PRODUCT CAMPAIGN BULLETIN

NUMBER: WQE-41
DATE: February 2013

SUBJECT: Optional Genuine Subaru Puddle Lights

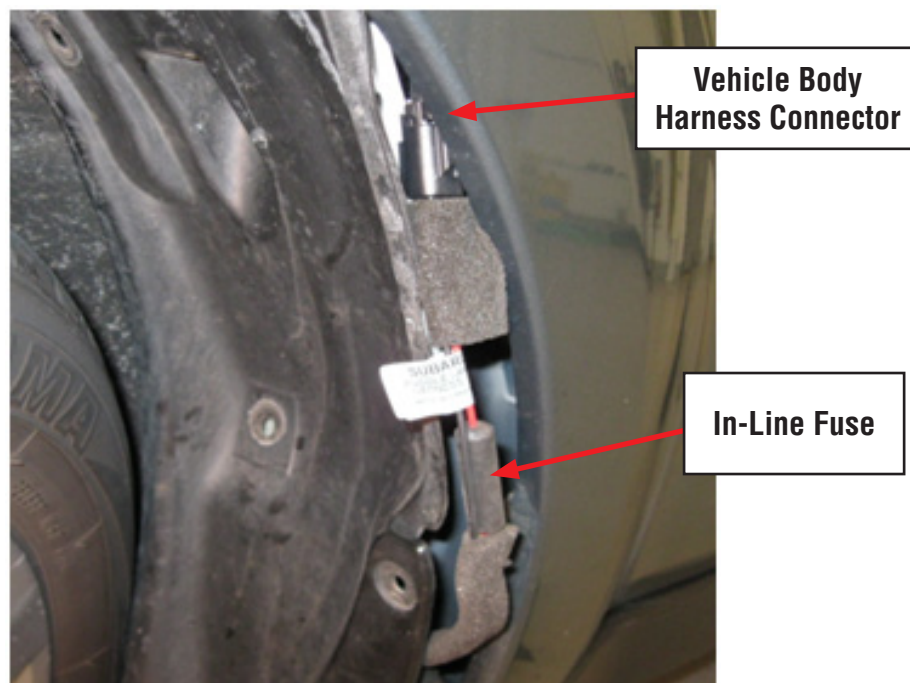
- A Forester is shown in the photo on pg. 4 for illustration only.
- Splash guard removal may also be required for access to the splash shield retaining clips.
- Retaining clip locations will vary by model.
- See **Appendix B** for samples of retaining clip locations by model.
- The photos below show a puddle light harness **without** the in-line fuse on the left and the current replacement harness **with** the in-line fuse on the right.

No in-line fuse installed

With in-line fuse installed

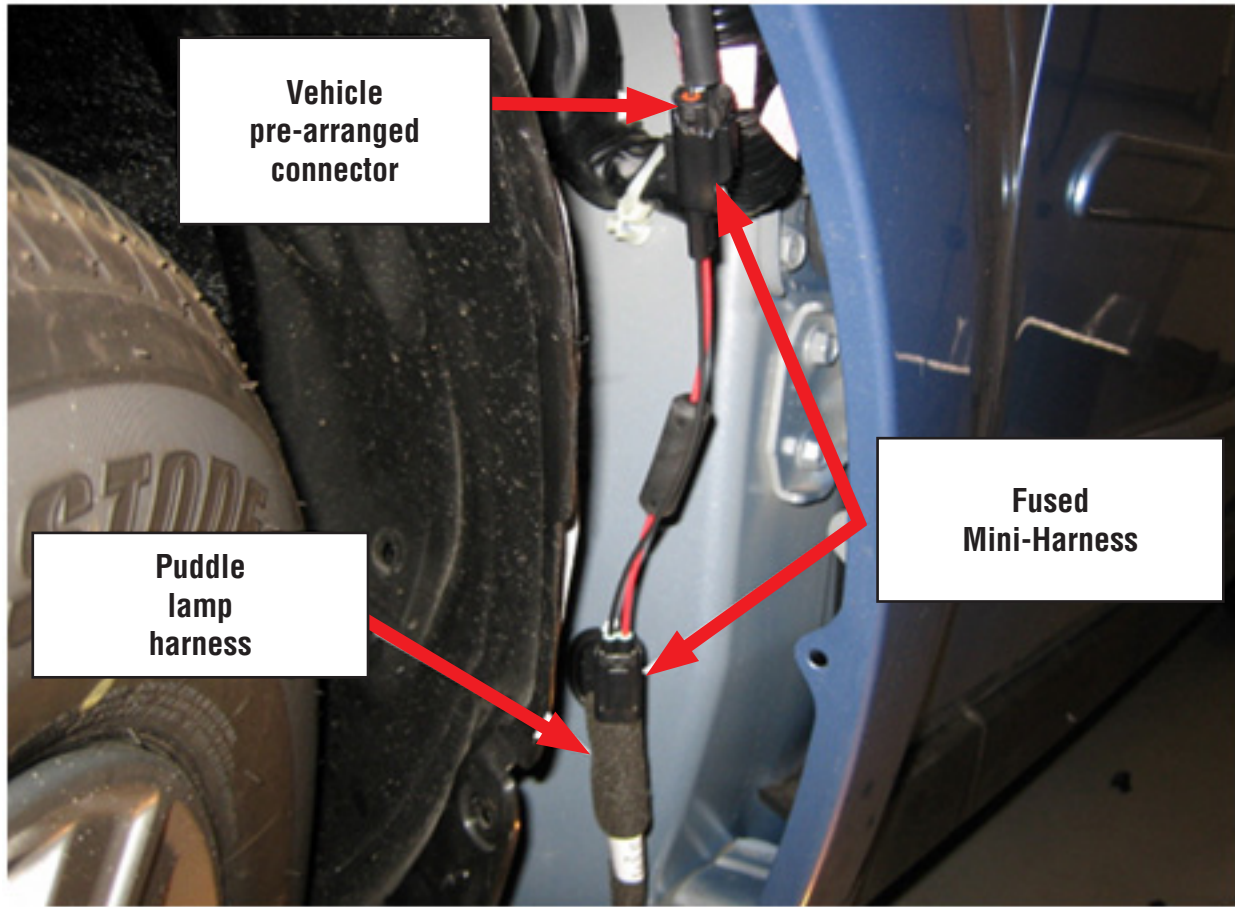
3. Once the splash shield has been moved enough for access, inspect the puddle light harnesses.
 - a. If the vehicle already has an in-line fuse in the red power wire within a few inches of the vehicle connector as shown in the photo below or a Fused Mini-Harness as shown in the photo on pg. 7 and both lights (all 4 LED bulbs) operate, no further action is required on that side.

Fused Mini-Harness

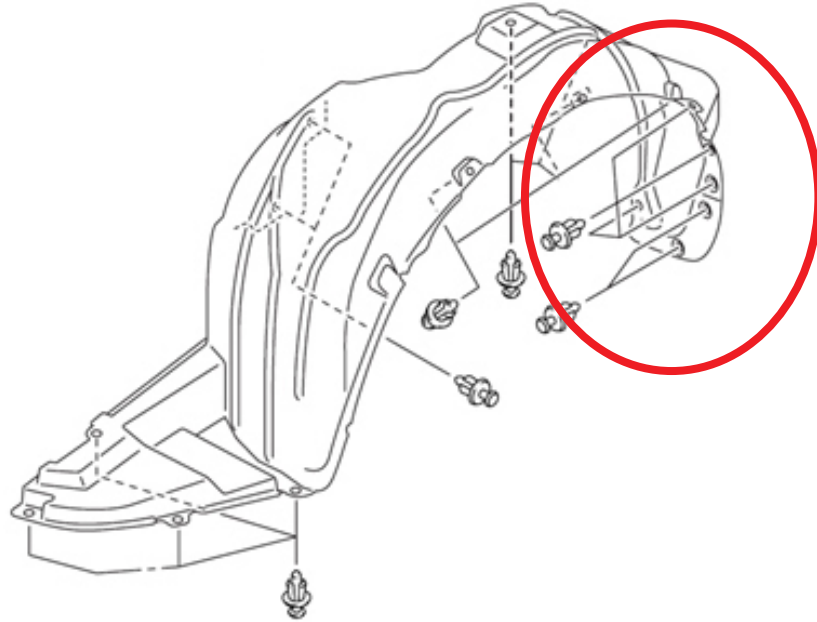
- b. Next, check the other side of the vehicle starting again at Step 2. Once inspection of both sides of the vehicle is complete and fuses are confirmed to be on **BOTH** sides of the vehicle, proceed to Step 5, otherwise see “c” below.
- c. If no in-line fuse or Fused Mini-Harness is present, unplug the puddle light harness connector from the vehicle body harness connector and install the Fused Mini-Harness as shown in the reference photos below.

Route the completed harness behind the splash shield. Use electrical tape to secure any excess harness out of the way avoiding any areas where it may be exposed to sharp edges or become pinched. **Do not reassemble yet.** Once both sides of the vehicle have been completed, proceed to the next step.
